ADDENDUM NO. 1

September 8, 2026

PORTAGE HIGH SCHOOL: 2026 RENOVATIONS PROJECT
6450 U.S. Highway 6
Portage, IN 46368

TO: ALL BIDDERS OF RECORD

PARTIAL ROOF PLAN - UNIT B
SCALE: 1/16" = 1'-0"

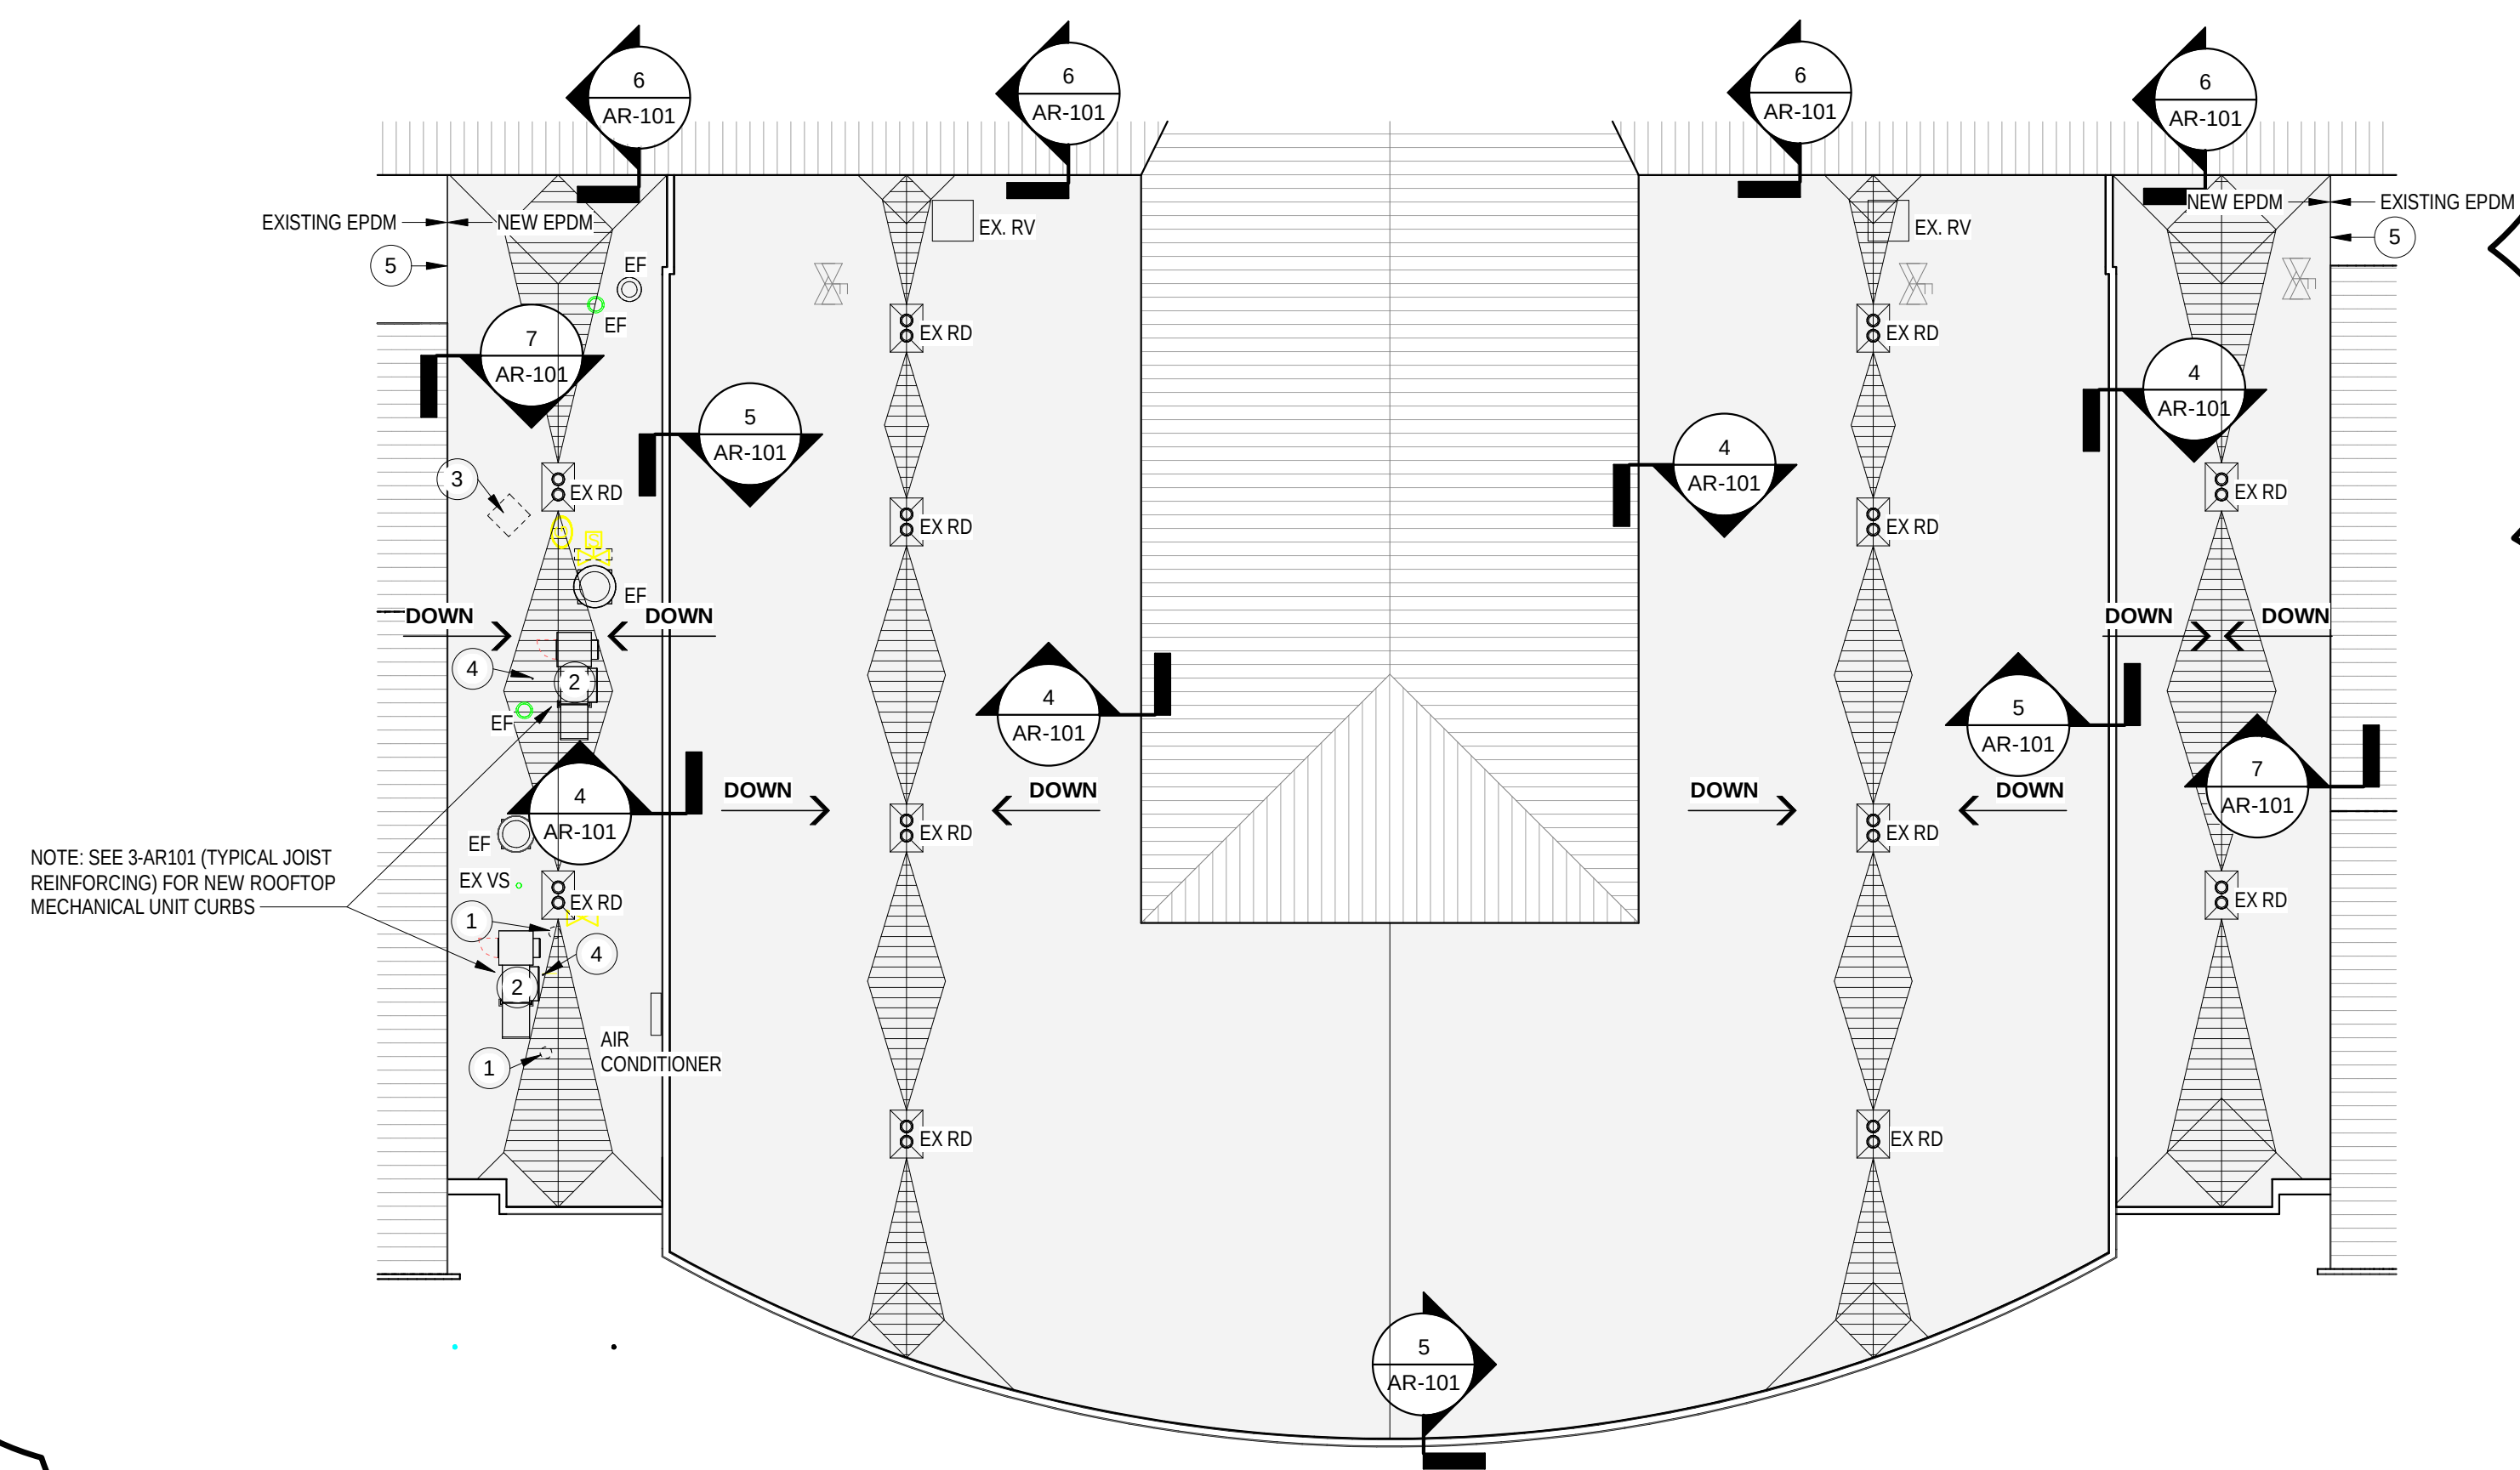
- C. ALTERNATE NO. 3: State the cost to provide New EPDM Roof Membrane replacement as shown on Drawing AR-101. **Base Bid:** Roofing Restoration required for new improvements for the Unit B Kitchen Improvements.

ROOF SCOPE NOTE:
SHADED AREA INDICATES EXISTING EPDM ROOFING MEMBRANE TO BE REMOVED AND REPLACED WITH NEW EXISTING COVER BOARD TO REMAIN WHERE APPLICABLE AND NEW COVER BOARD TO BE INSTALLED UNDER ALL NEW ROOFING MEMBRANE.
